APPEAL STAFF REPORT – DE NOVO HEARING

Appeal number.....A-3-SCO-02-117, Davenport Barn
Applicant.....David Luers
Appellants.....Commissioners Sara Wan and Pedro Nava; Sierra Club; Coastal Organizers and Advocates for Small Towns (COAST)
Local government.....Santa Cruz County
Local decisionApproved with Conditions (November 13, 2002)
Project location.....Roughly one acre parcel located at the intersection of Old Coast Road, Davenport Avenue, and Highway One in the town of Davenport on Santa Cruz County's north coast.
Project descriptionDemolish a deteriorated barn, remove a 5-foot diameter and approximately 70-foot tall eucalyptus tree, and construct a 3-story, roughly 6,400 square foot structure (4,316 square feet of enclosed interior space and 2,084 square feet of wrap-around decks/walkways) that would include two residential units and a retail sales operation (the project is roughly half residential and half retail), with an approximately 4,700 square foot 10-car parking lot and associated hardscape (patios and paths) and landscaping.

Staff recommendation ...Denial

Summary of staff report and staff recommendation: The Applicant proposes to demolish the badly deteriorated Daven

PROJECT PLANS

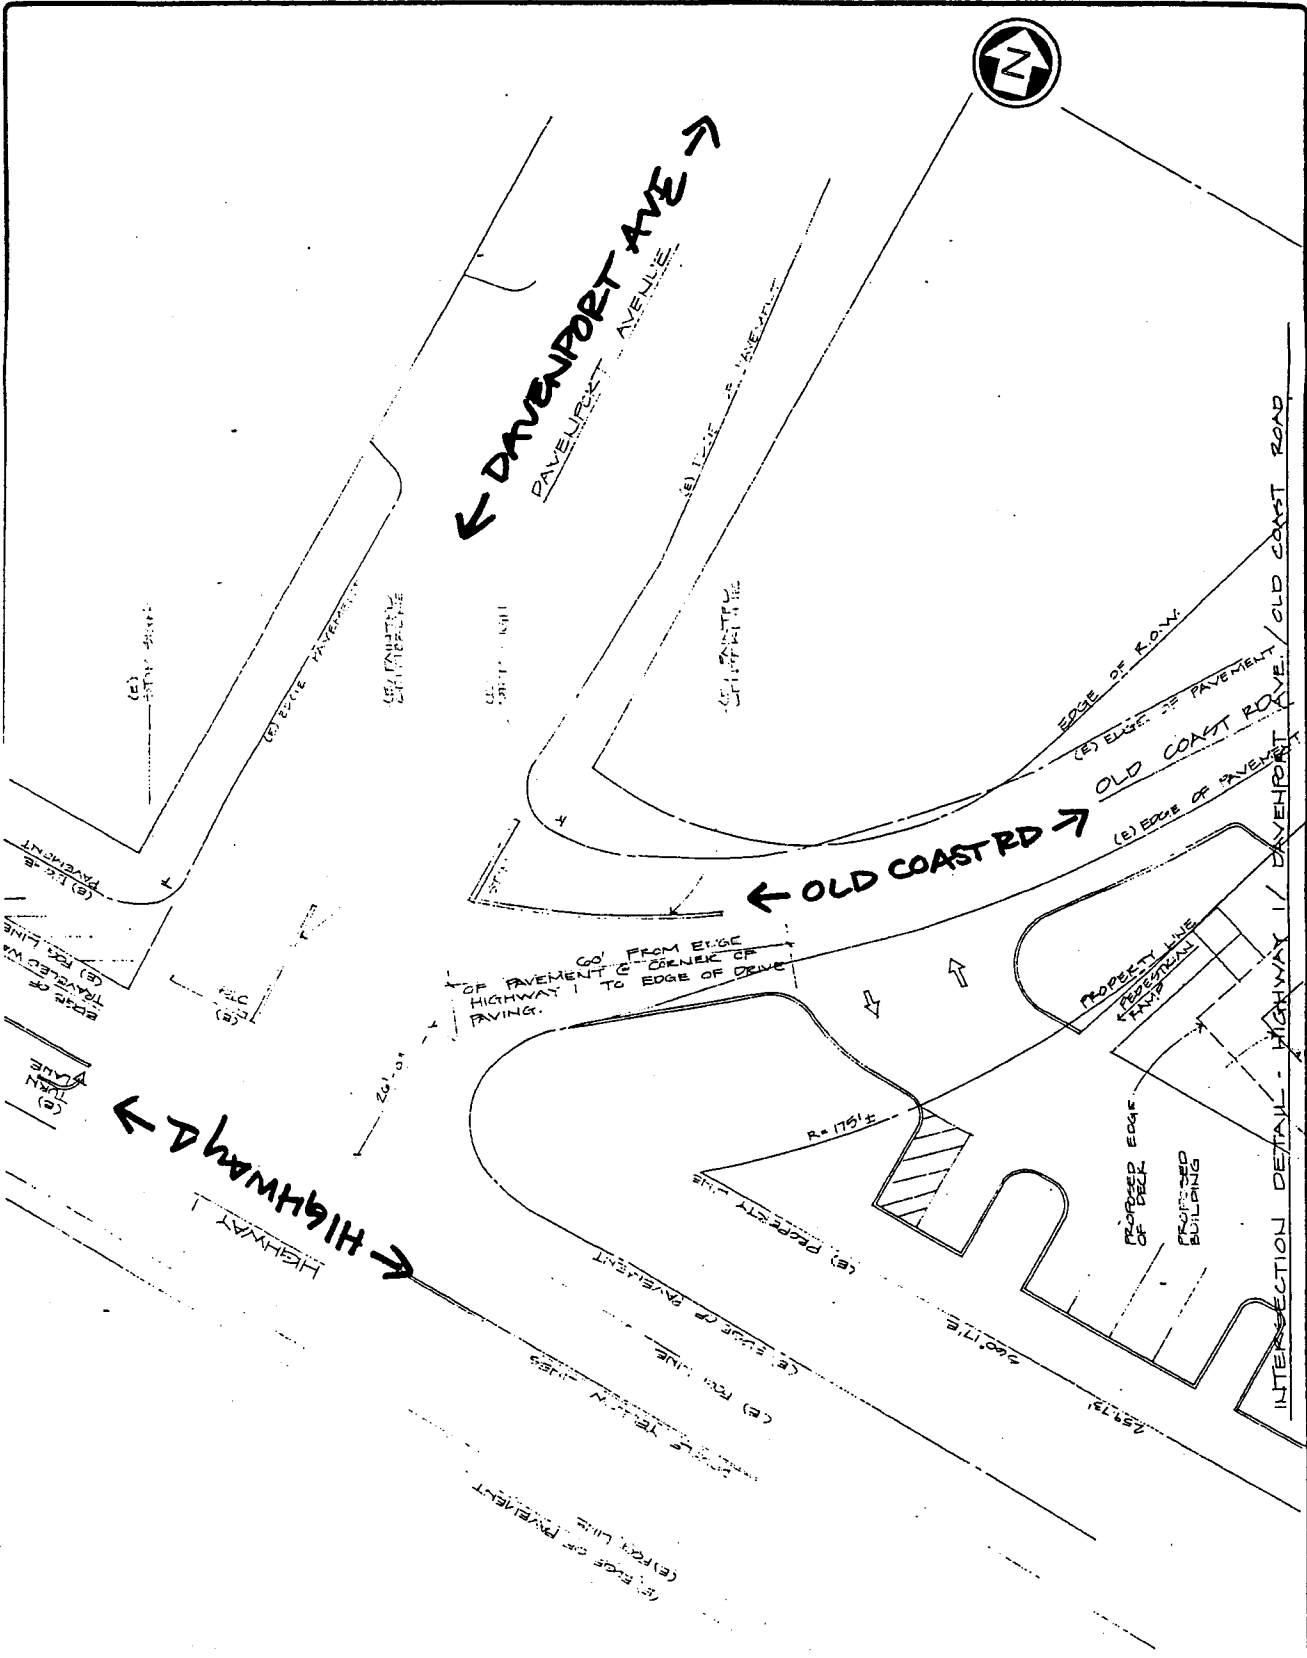
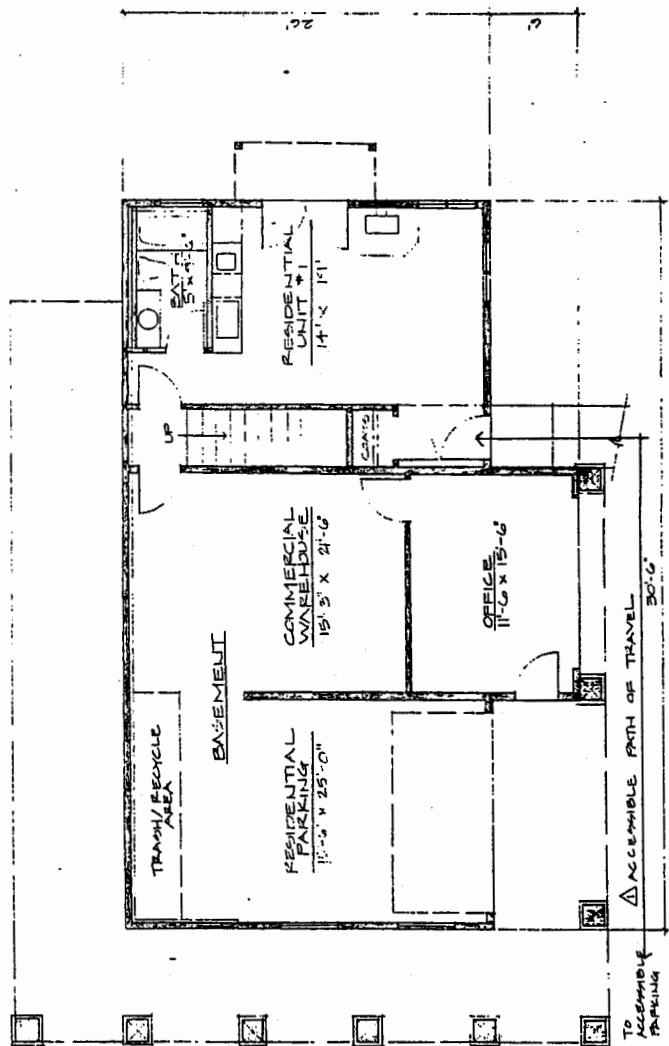
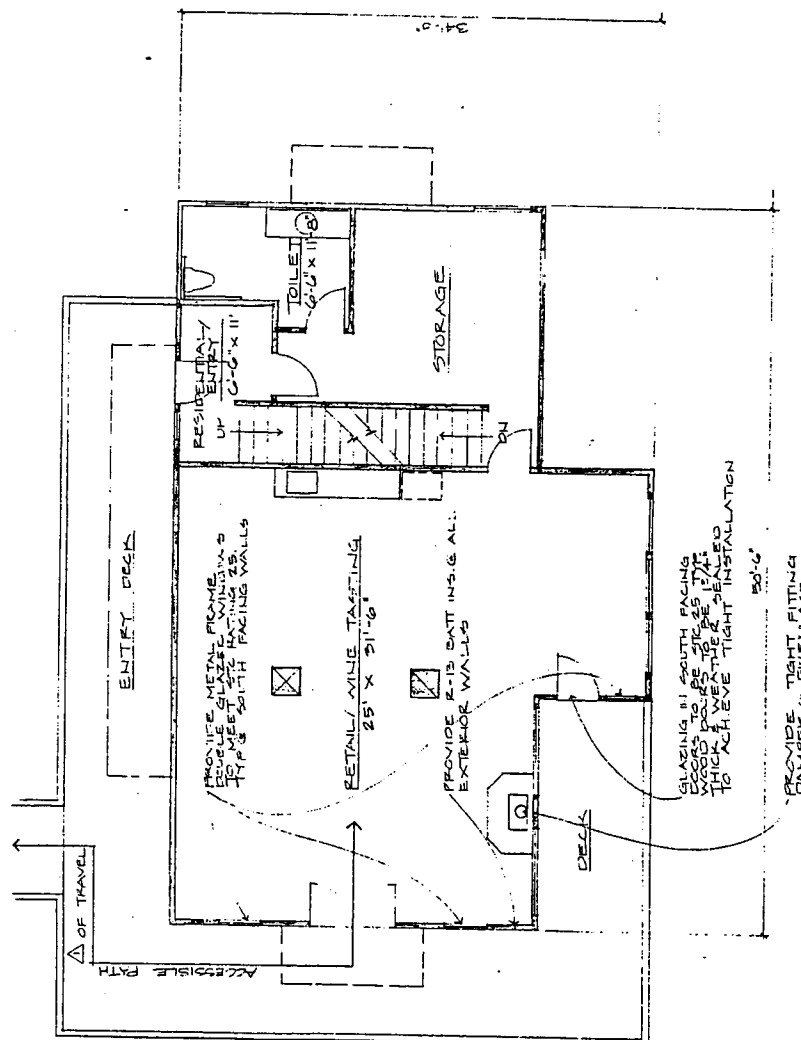
²¹ Again, there has been confusion on the overall height proposed. The [proposed project plans show the height to be in excess of 35 feet, with a maximum grade to pitch height of 37 feet (see approved plans in exhibit D). In the time since this item was appealed, the County subsequently indicated that the Applicant agreed to lower the height (to 32 feet 4 inches on the west elevation and 34 feet 8 inches on the east elevation); that this lower height is what is shown on the project flagging, staking, and photo simulations (see exhibits C and E); that it was the lower height that was reported to the Planning Commission when they approved the project; and that although there was no written condition or requirement, that the County would enforce the lower height through their coastal permit (personal communication from County planning staff). Nonetheless, the proposed project plans do not show this lower height and any unwritten arrangements with the County carry no force or validity in this de novo review by the Commission. The barn appears to be around 28 feet in height. The Applicant asserts that the barn is about 30 feet in height and that the proposed structure would be about 5 feet taller. Given the uncertainties, an exact difference in height is difficult to measure. Suffice it to say that the proposed building would be taller by five feet than the existing barn, and maybe more. Again, see also Applicant's January 28, 2003 submittal and Commission Staff's response to it regarding this point (exhibits F and G respectively).

The Applicant again confuses the issue regarding the height of the proposed building. As noted in the staff report, Again, the approved plans show the height to be in excess of 35 feet, with a maximum grade to pitch height of 37 feet (see approved plans in staff report exhibit D). In the time since this item was appealed, the County subsequently has indicated that the Applicant agreed to lower the height (to 32 feet 4 inches on the west elevation and 34 feet 8 inches on the east elevation), and that this lower height is what is shown on the project flagging, staking, and photo simulations (see staff report exhibits C and E), and also it is the lower height that was reported to the Planning Commission when they approved the project (personal communication from County planning staff). Although the County also subsequently indicated that the lower height would be what would be enforced in the County coastal permit, there is no corresponding condition to implement the lower height and the approved plans do not show same. As far as the County's written approval stands, the approved plans show a maximum proposed building height of 37 feet.

APPLICANT'S PHOTO SIMULATION
(POST PROJECT - BARN GONE)

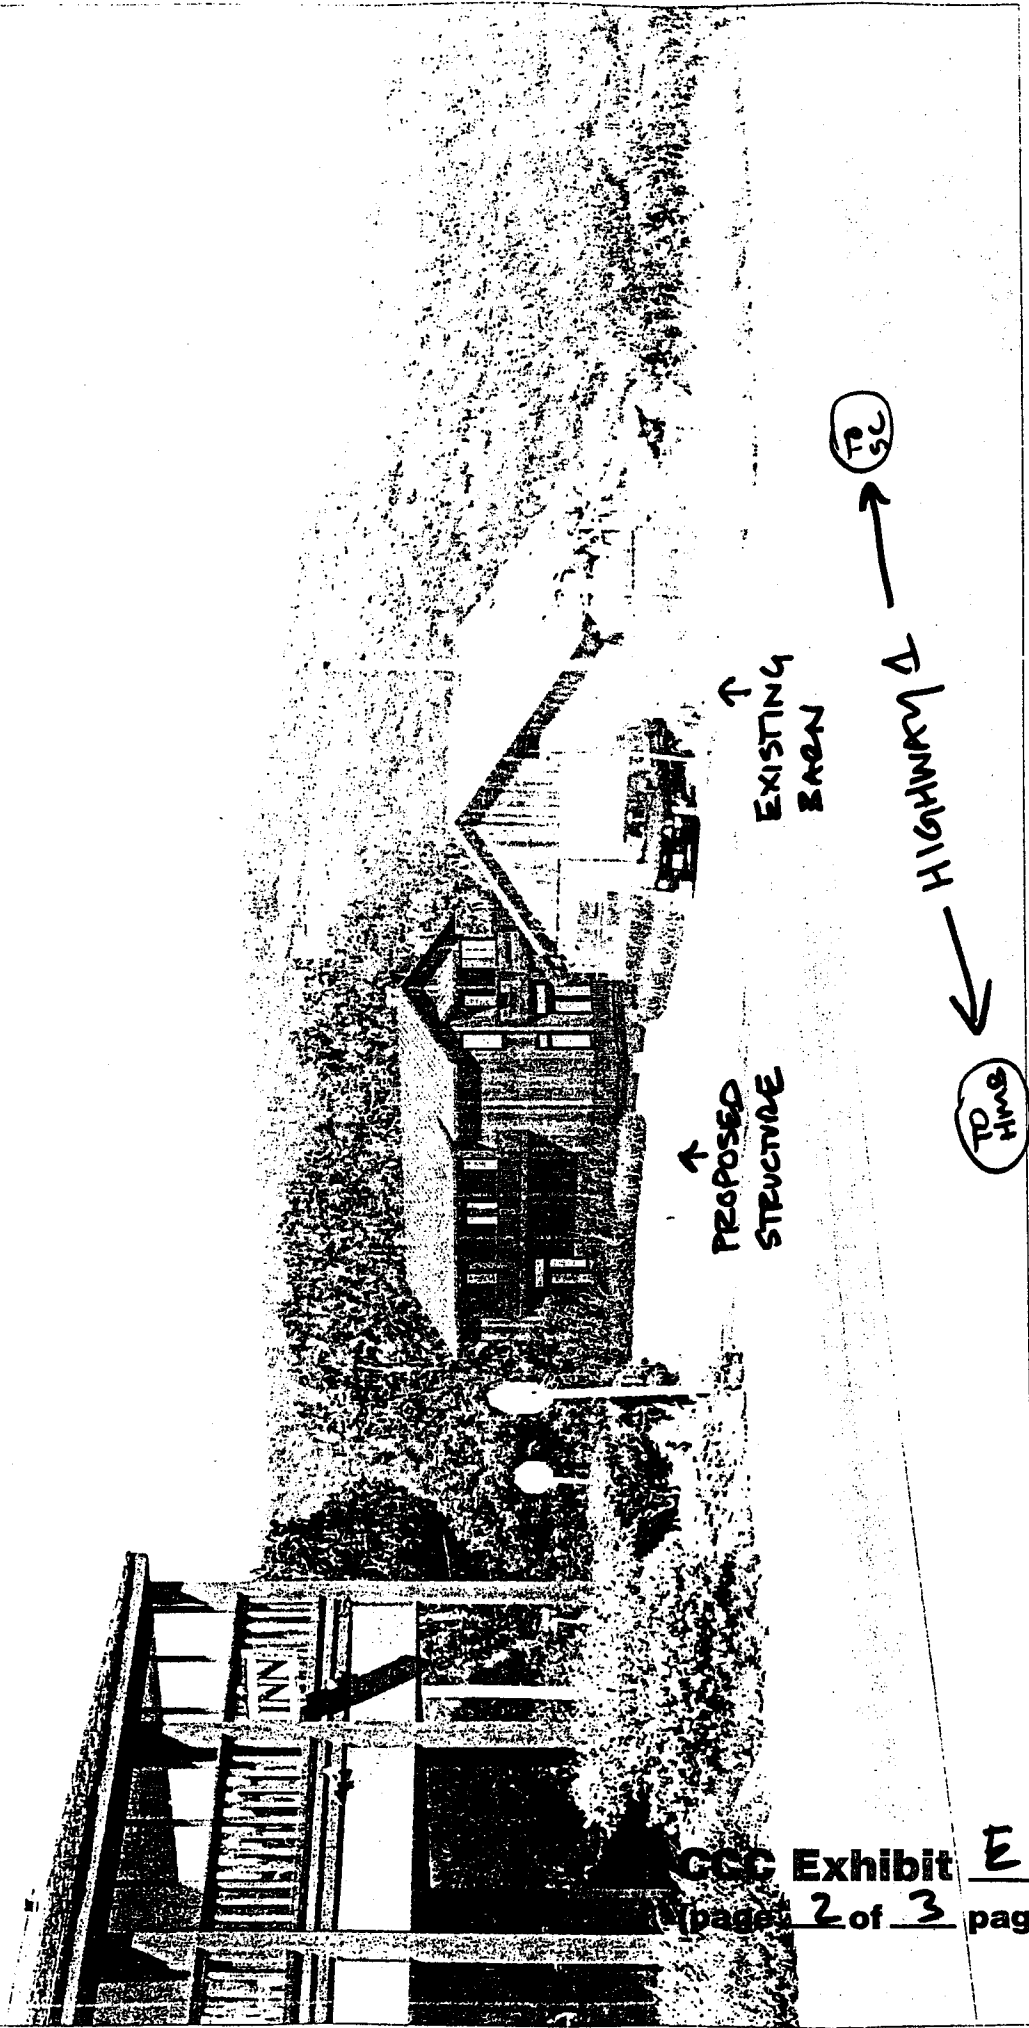
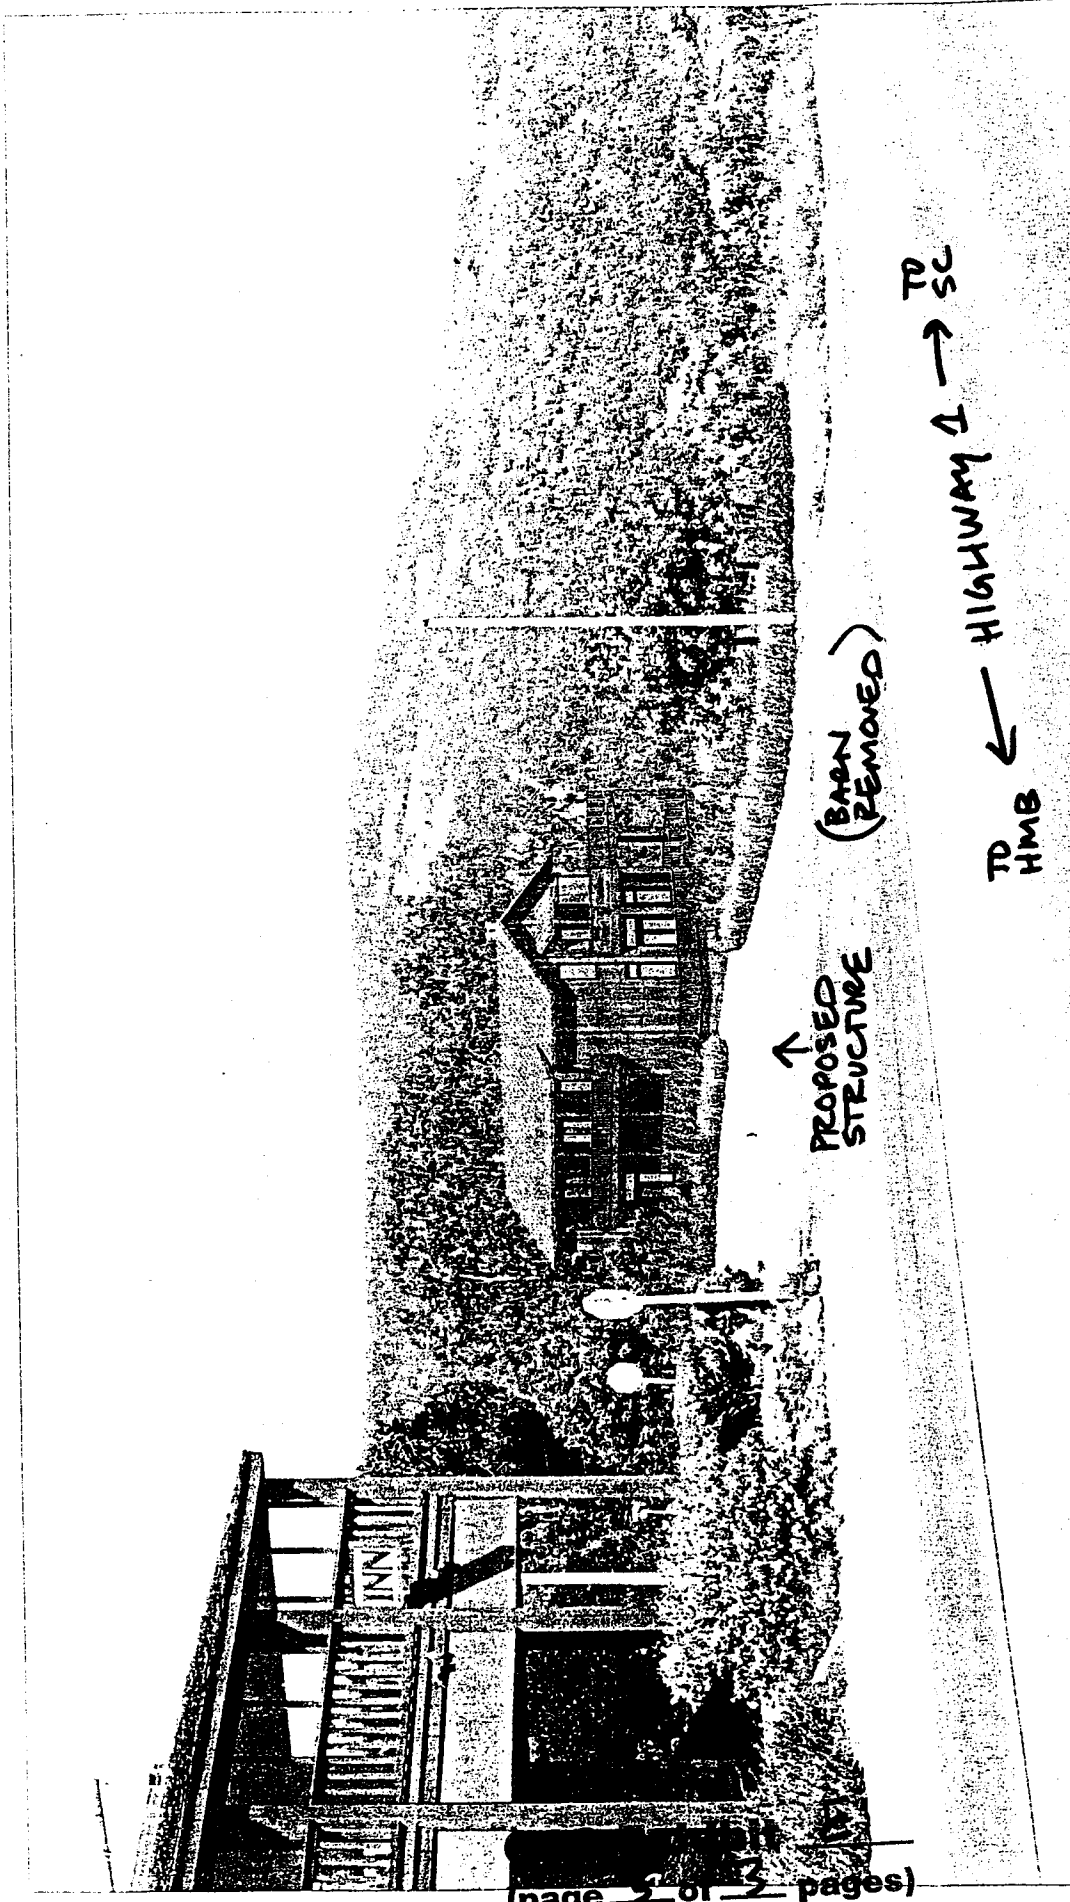
The Applicant's photo simulations and the photos of the project staking required by the County give a general sense of the area that would be occupied by the proposed main structure (see exhibits C and E). However, the staking and photo simulations underestimate that change proposed because: the project staking did not include all structural elements (such as all wraparound decking) and was keyed to a lesser height than that shown on the proposed project plans; the photo simulations omit vehicles parked in the large parking area that would be a dominant visual element immediately adjacent to the Highway; and neither include the 6 foot stucco wall/fence along the plateau's edge.
